TOWN OF HORIZON CITY Planning and Zoning Commission Staff Report

Case No.: SUB-002496-2022 & SUB-002497-2022

Rancho Desierto Bello Unit Fifteen (RDBU15)

Application Type: Preliminary & Final Plat

Attachment 4- Preliminary & Final Plat Phase One

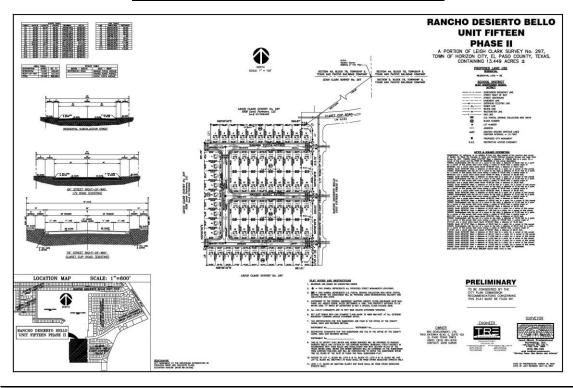
1. Identify the original LTV Road delineation that is to be vacated; this delineation should resemble the information provided on the final plat.

- 1. The utility easements that are identified to be vacated by separate instrument on the face of the plat will need to be vacated and such instrument(s) finalizing the vacation(s) shall be provided to the City prior to the plat being recorded.

- 2. Based on the rendering that was emailed on March 15, 2022, it seems that a portion of the 25' foot easement, where it traverses the access to and a portion of the proposed ponding area, is proposed to remain in place along with the existing water line. If in fact this is the case, City staff will recommend that the pond not be accepted by the City for maintenance as the location of the water line within the ponding area is not in the best interest of the City. Please revise the location of the ponding area and access so that it is completely separate from the easement and water line.

- 3. The 25' utility easement on Lot 30, Block 57, as shown on the abovementioned rendering, is not identified as such on the face of the plat. Being that the easement is significantly wide, it will likely create issues for the future property owner as they will not be able to construct any structures on that easement. Please adjust the lot lines to ensure that the easement is outside of the lot; the easement may need to be dedicated as a utility right-of-way to the HRMUD.

- 4. Please confirm that the portion of the existing 25' easement will be vacated where it traverses Lot 28, Block 57. If not, the previous comment also applies to this lot.

- 1. Provide Closure with metes and bounds description.
- 2. Provide instrument documentation for the Easement to be located on Block 64.
- 3. Provide street name list on plat.
- Block 57 (East and West Side), lots 15-26 address numbers shall be 3 Digits (See Section 107.090 Ordinance 00107). Did no provide approval email by E. P. County.
- 5. Address review/approval by the El Paso County 9-1-1 District is required.

- 1. Verify location of existing easements.
- 2. Show all proposed easements on preliminary plat.

- 1. Verify location of existing easements. Provide instrument numbers for easement vacations.
- 2. Show all proposed easements and provide recording instruments.
- 3. At the ponding area, would it be possible to vacate the existing easement at the pond and expand the easement on the adjacent property. The HRMUD could gain access to the easement from the proposed 25' easement from Block 57, Lot 30. Lot 30 would need to be reconfigured to create a Utility ROW.

4. Provide Restrictive Covenants for the subdivision.

Attachment 4- Preliminary & Final Plat Phase Two

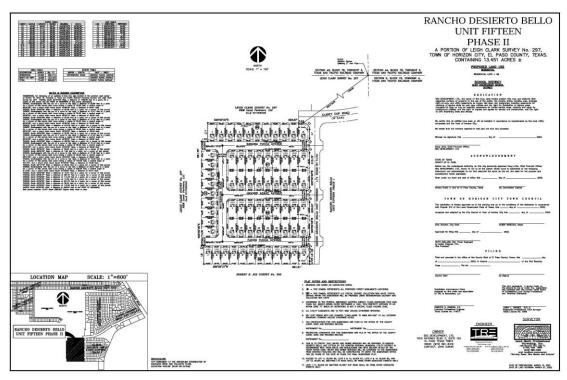
• The plat does not include current topographic information as required by Section 4.2.2.6 of the Subdivision Ordinance (Exhibit A of Chapter 10 – Subdivision Regulations of the Municipal Code). Please provide a revised plat that provides this information.

• The proposed location of the US Postal Service Collection Box Unit for this subdivision is not provided on the face of the plat. Please verify the location and identify it on the plat in accordance with Plat Note #3.

- 1. Block 66 north side, provide description for R.A.E. (Provide description in legend or on plat notes. Is it "Restrictive Access Easement"?)
- 2. Provide a copy of the restrictions and covenants to be recorded, if any.
- 3. Missing list of the street names on the plat.
- 4. Provide closure for metes and bounds.
- 5. Blocks 70 (EAST AND WEST SIDE), lots 1-9 address numbers shall be 3 DIGITS (see section 107.090 ORDINANCE 00107)

Did not provide email/approval by El Paso County 9-1-1 District. (Email with approval required prior to the final plat acceptance.

6. Address review/approval by the El Paso County 9-1-1 District is required (on final plat).

1. Provide a copy of the Restrictive Covenants for the plat and the recording instruments.
